**Re: Noon Day
2500 Second St NW
Request Permanent C.O. - Accepted
Engineer's Stamp dated: 12-5-13 (H14D067)
Certification dated: 11-26-14**

**RE: Grading and Drainage Plan
Noon Day (H14-D067D)**

RE: **Noon Day, 2500 2nd St**
Grading and Drainage Plan
Engineers Stamp Date 12/05/13 (H14-D067)
Engineer's Certification Date 11/4/2014

Re: Noon Day 2500 2nd St NW
Grading and Drainage Plan
Engineer's Stamp Date 10/31/13 (H14/D067)

ENGINEER'S SEAL	NOONDAY	DRAWN BY WCHWJ
	GRADING AND DRAINAGE PLAN	DATE 12-05-13
		21344-LAYOUT-10-10-13
12-05-13	1806 CENTRAL AVENUE SUITE 201 ALBUQUERQUE, NM 87106 (505) 872-0999	SHEET #
DAVID SOULE P.E. #14522		JOB # 21344

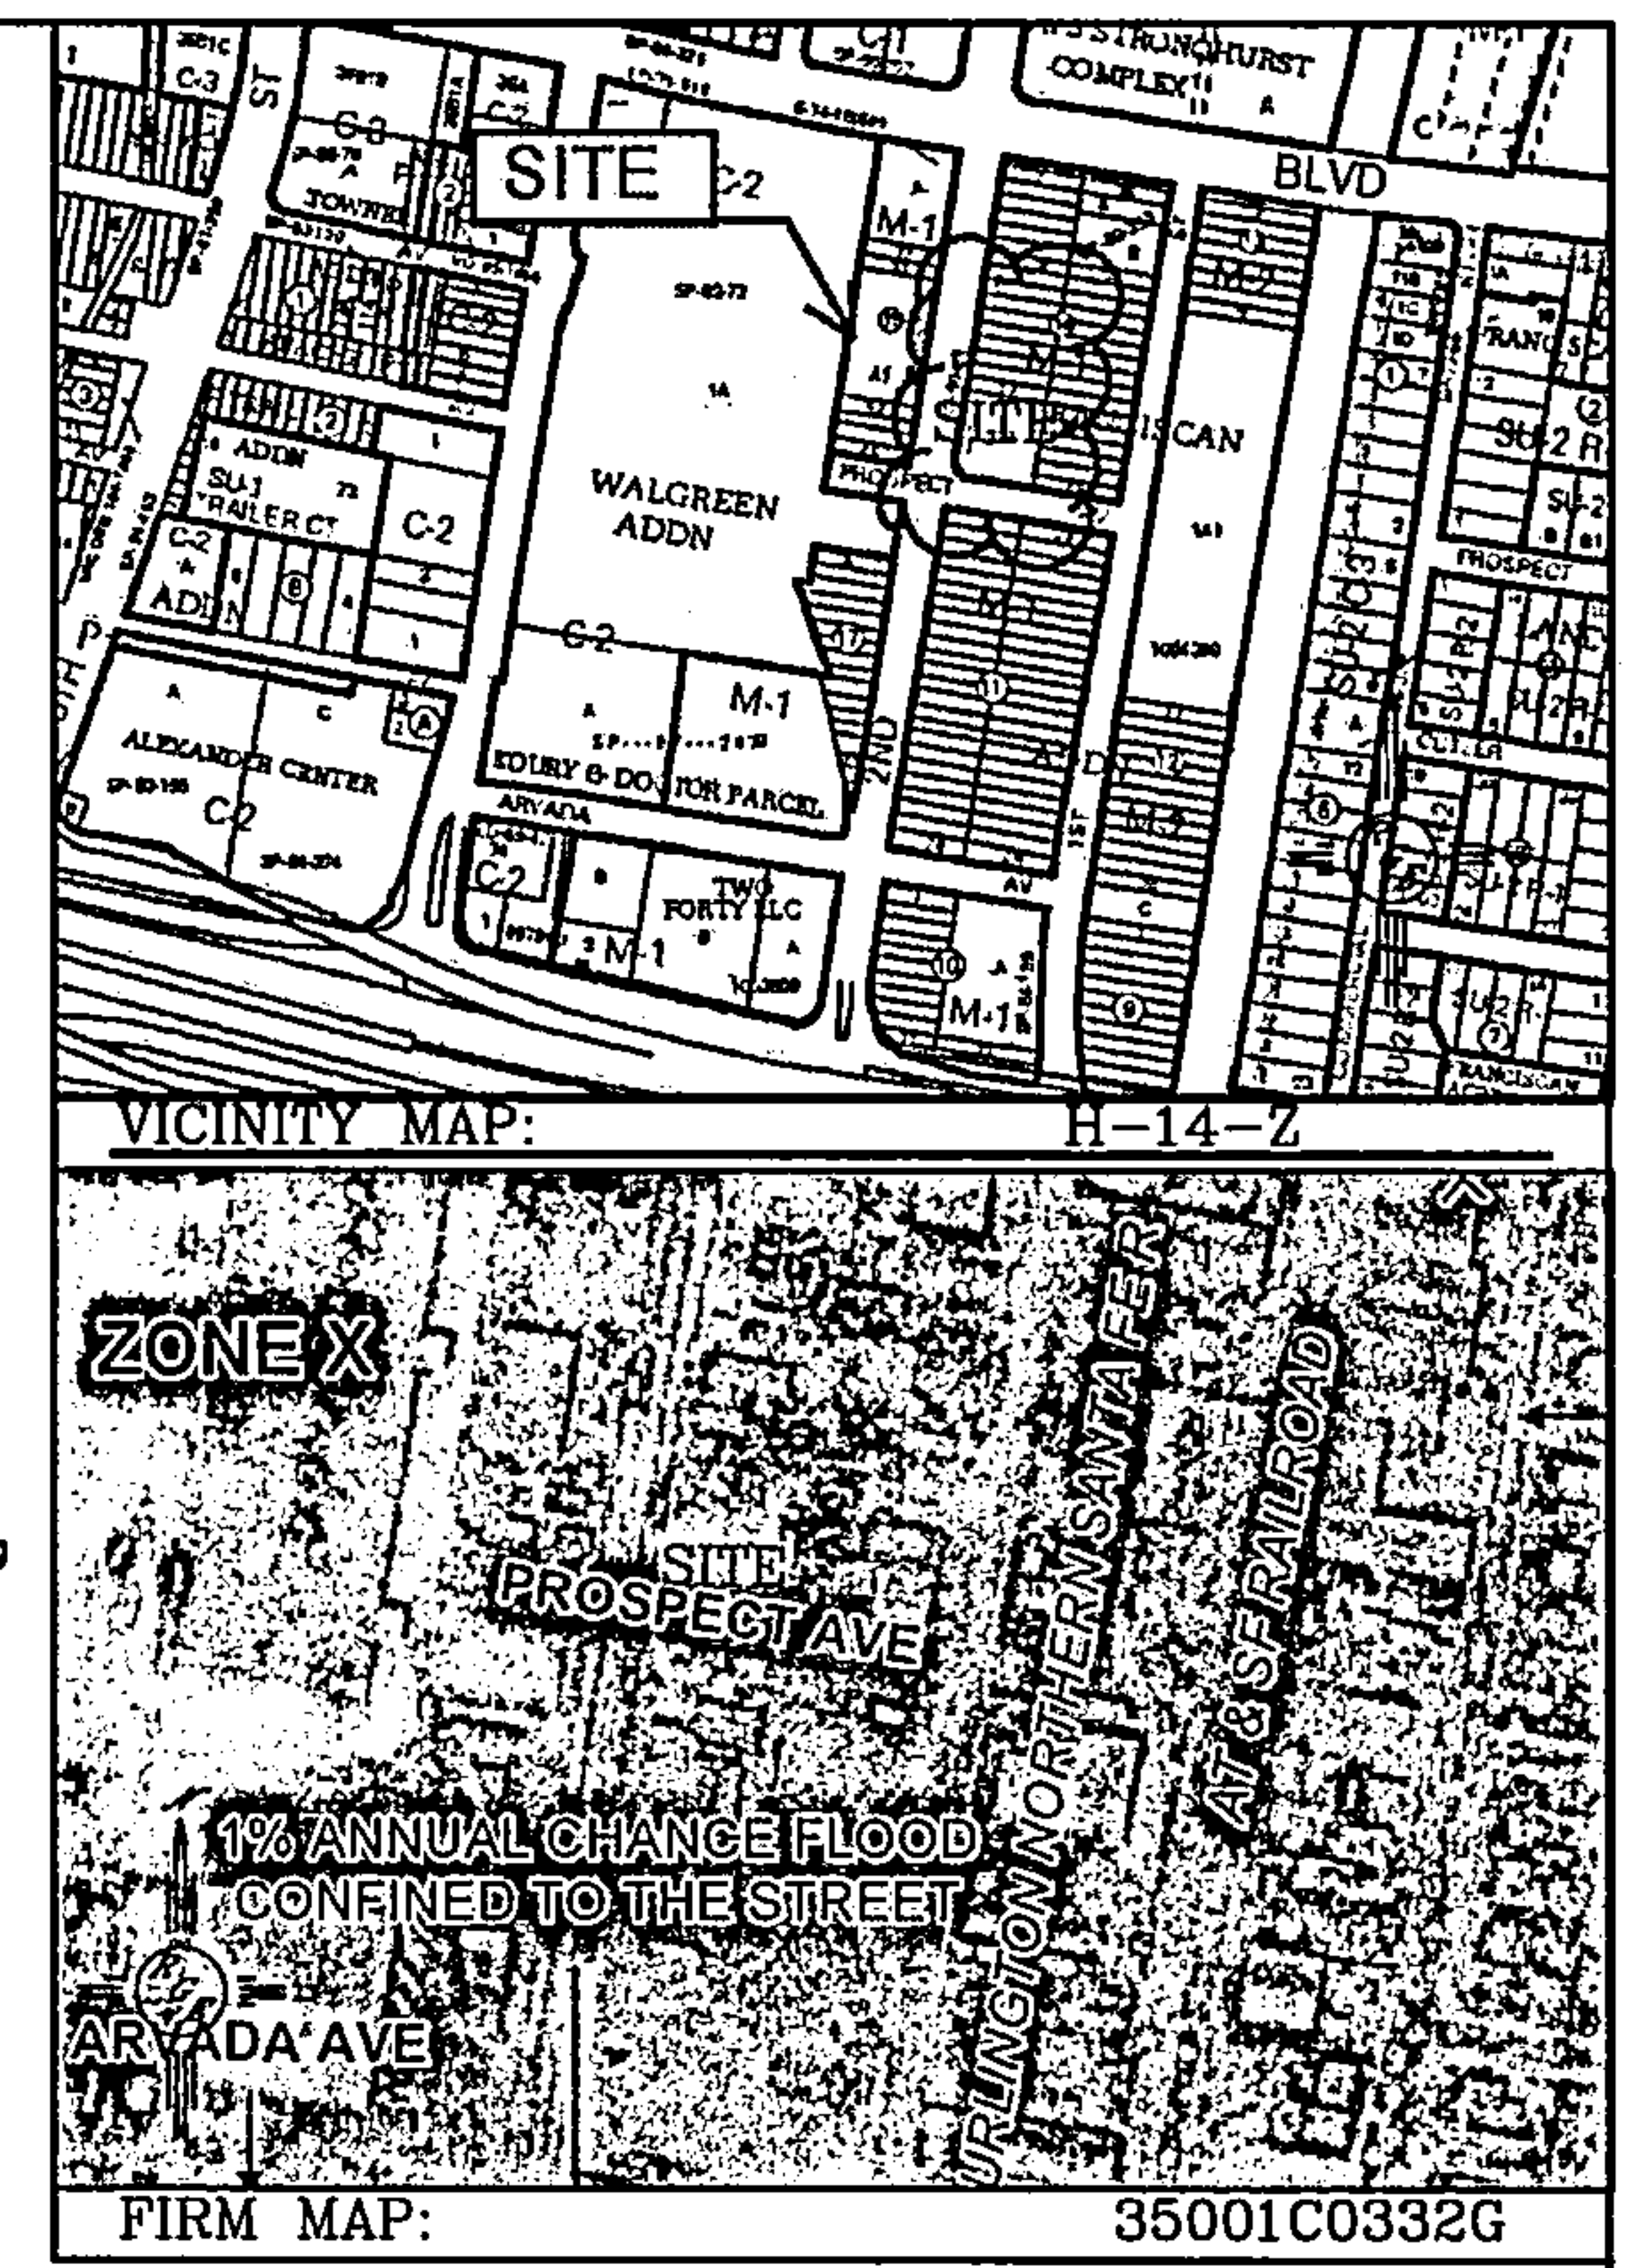
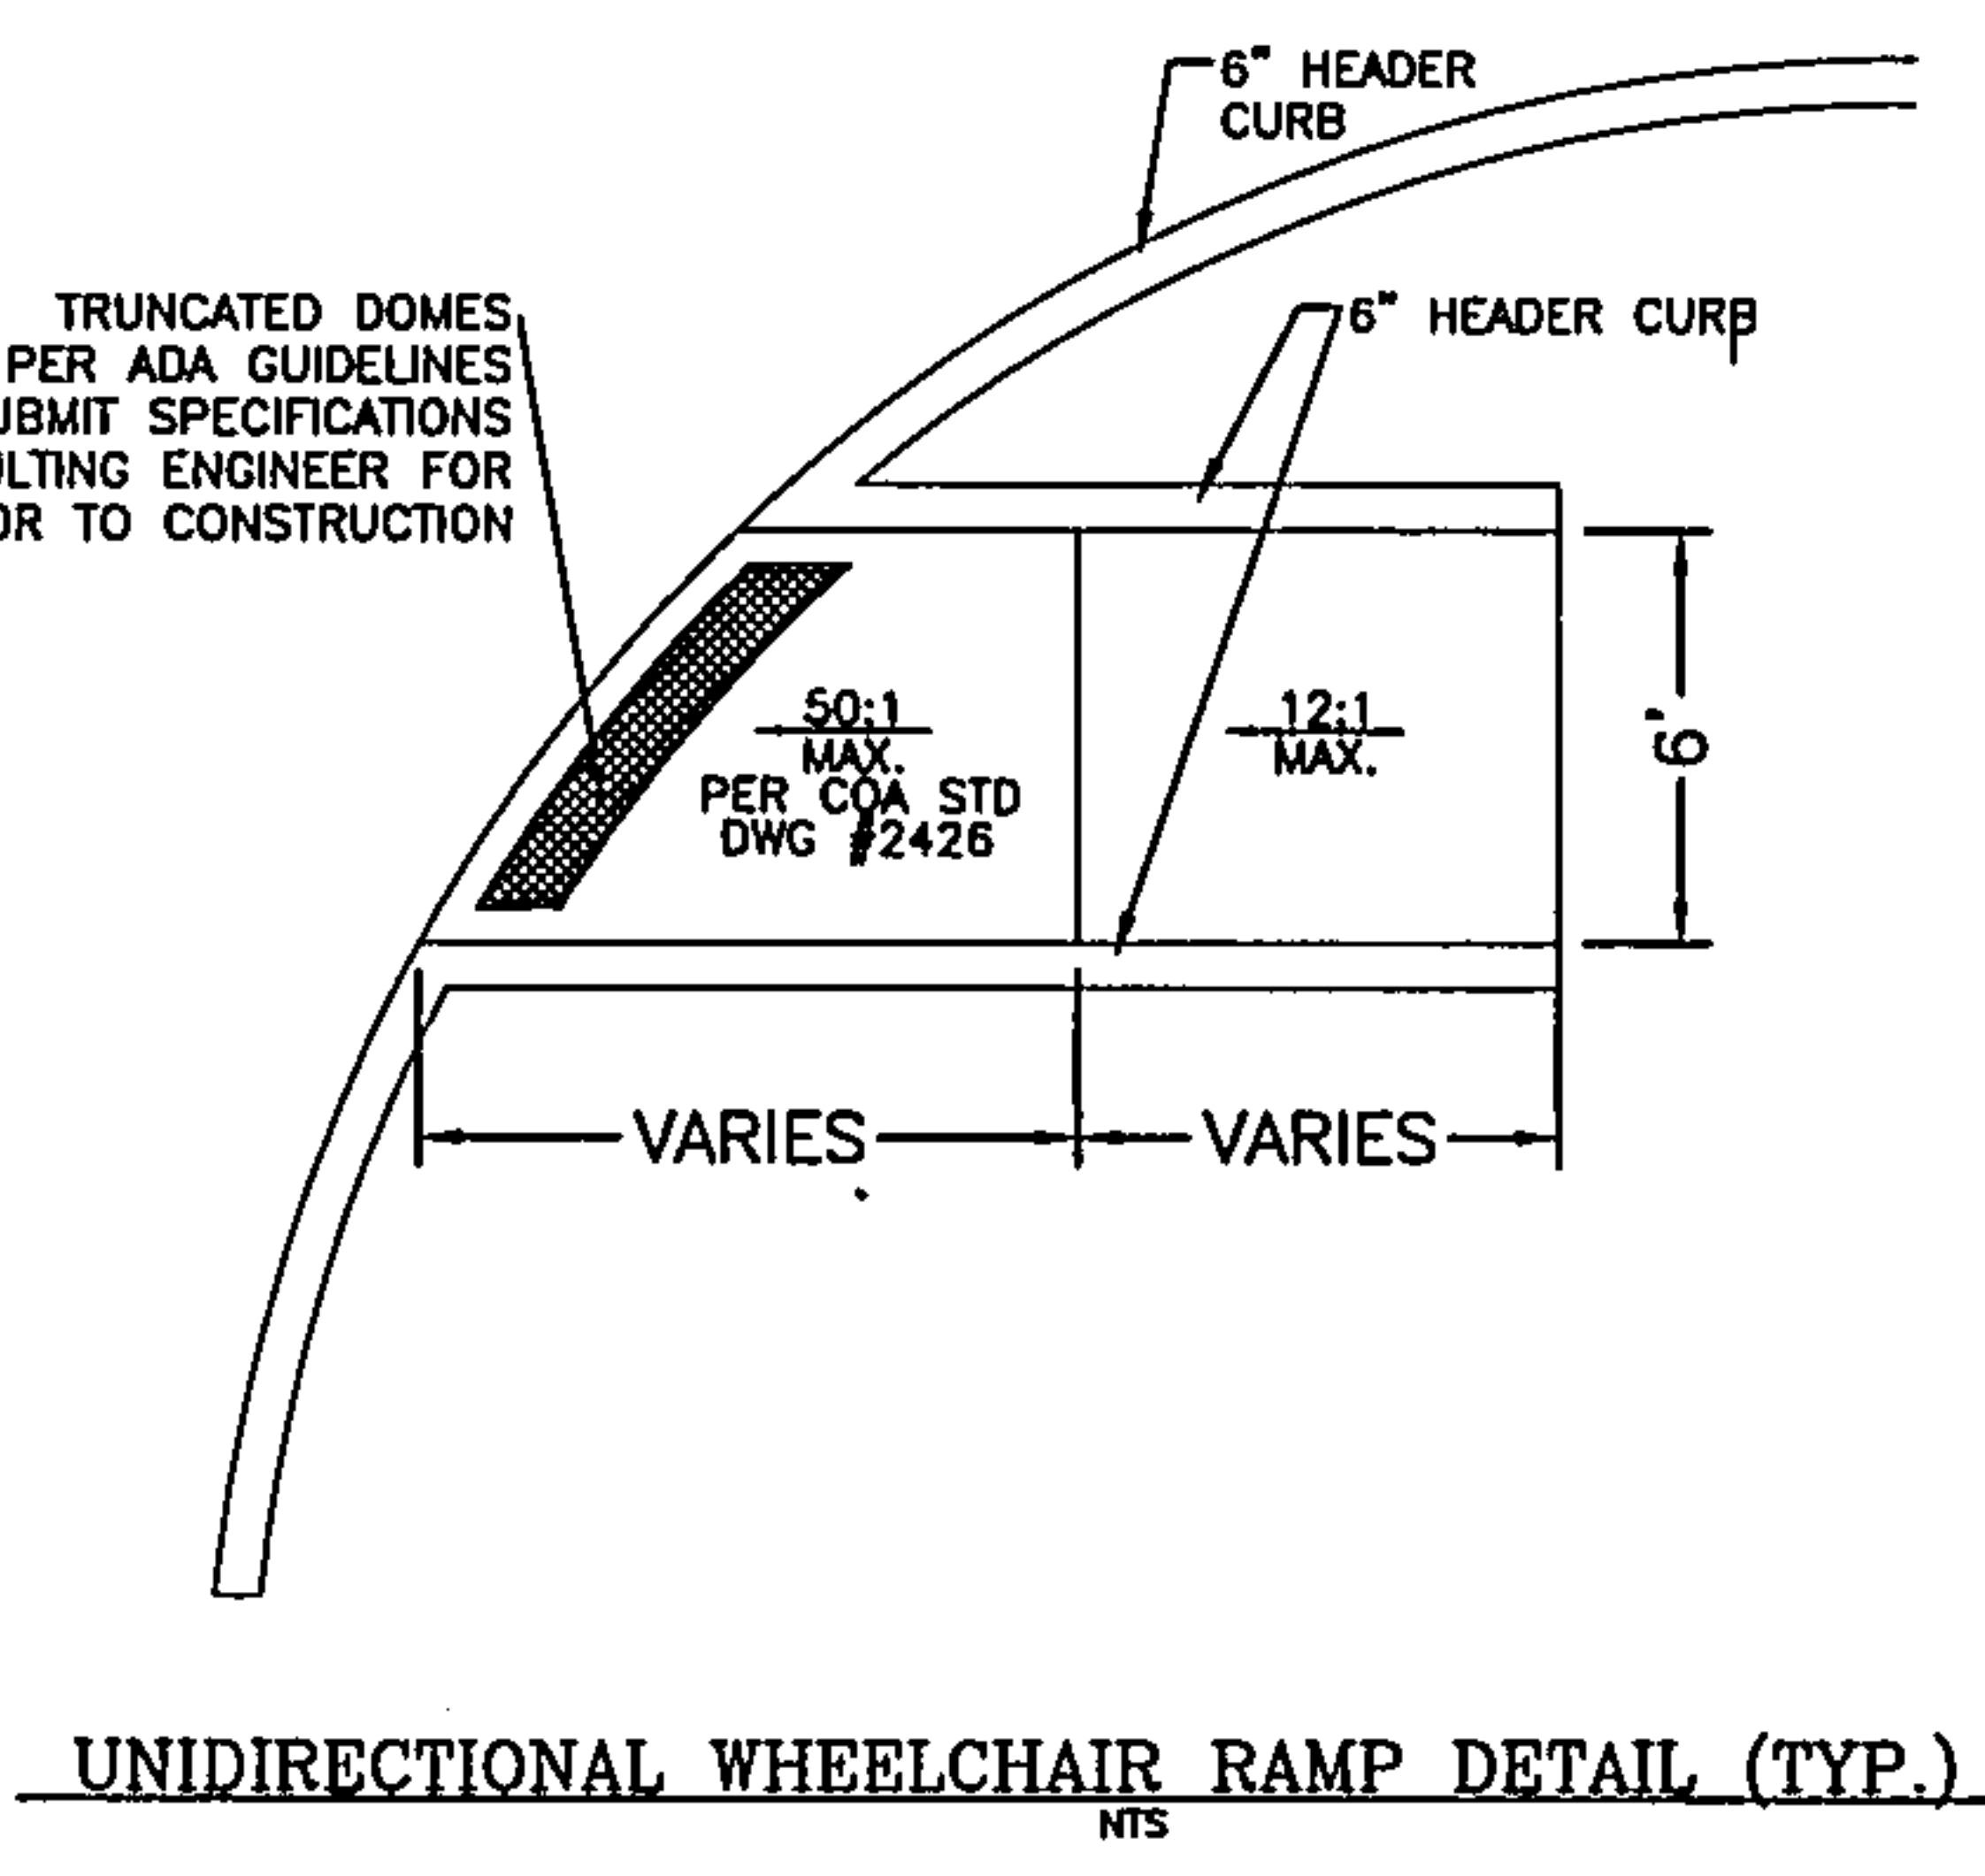
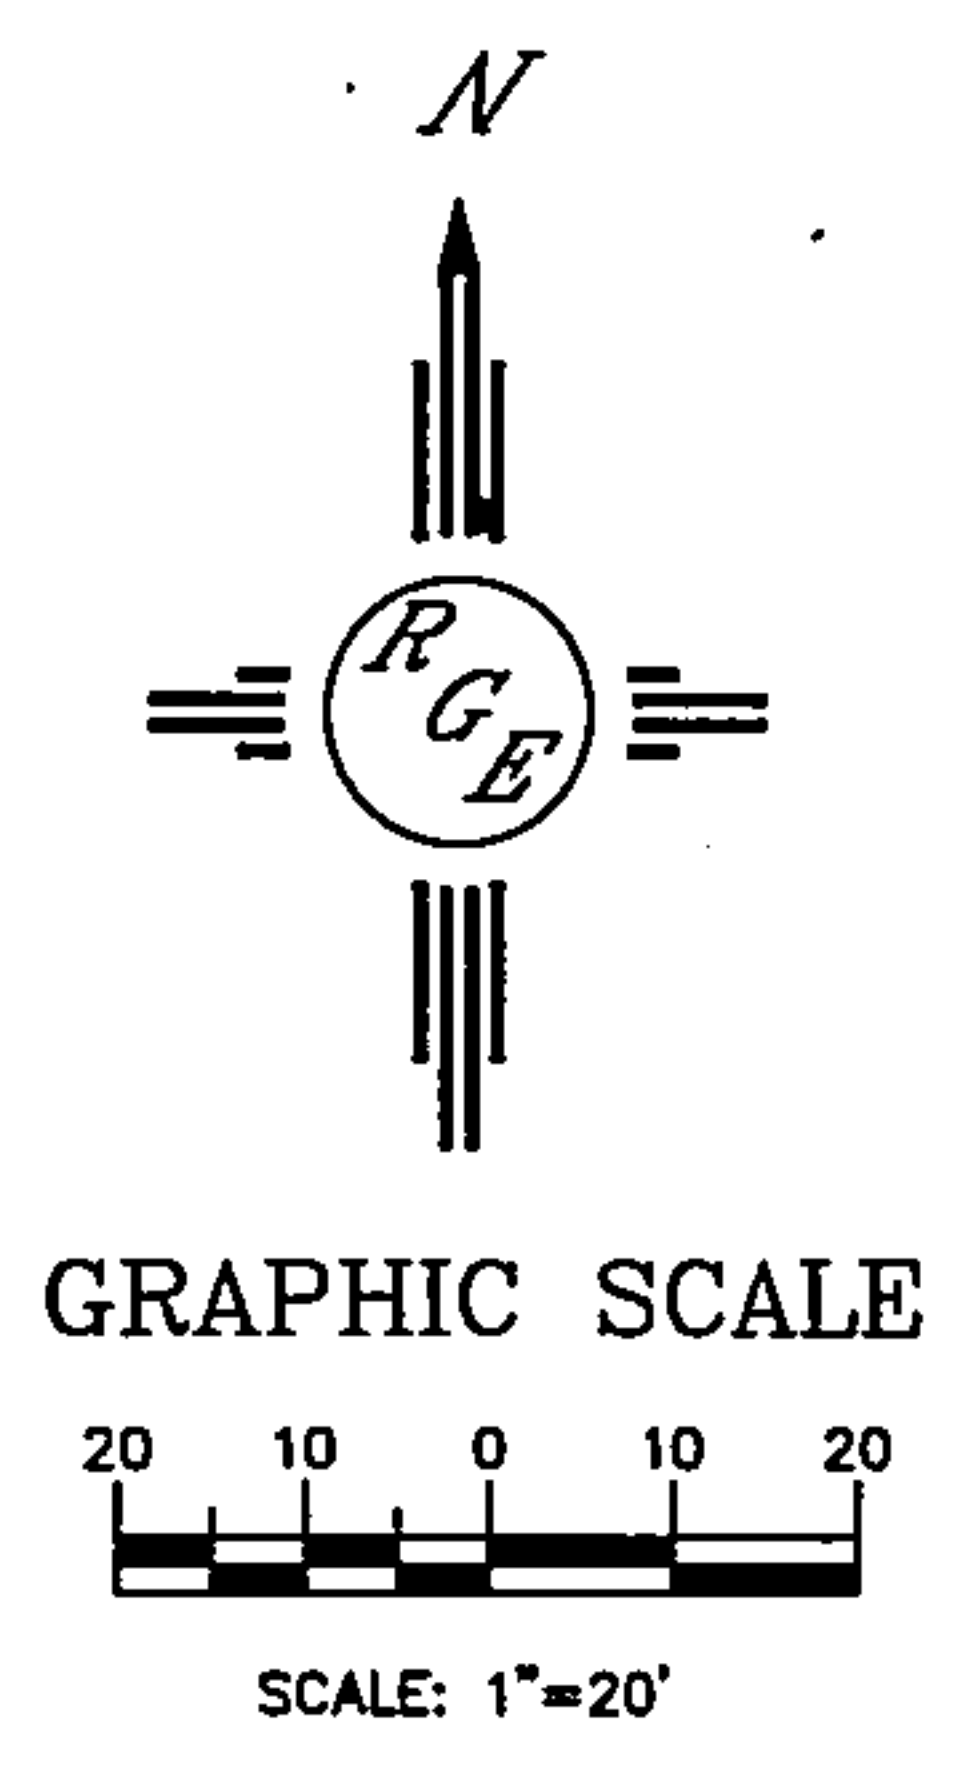
- Extend the sidewalk culvert plates two (2) feet passed the property line.
- Provide calculations.
- Water blocks are needed at the driveways.
- Provide spot elevations along the property lines.

1. Extend Sidewalk culvert plants 2' past property line
We have extended the plates two feet past the property line on second and two feet past the sidewalk on the corner of Second and Prospect
2. Provide Calculations
The calculations were erroneously not omitted. The calculation section has been enclosed.
3. Provide water blocks.
We have water blocks for both driveway, but due to the site grades we are not able to put at the right-of-way. To add a water block at Second Street would prevent the eastern portion of our site to drain out. The entire area draining out the driveways are higher than the flow line. To add the water block at the property line would cause more problems than it would solve. We request the parking lots be allowed to drain as proposed.
4. Provide spot elevations along property lines.
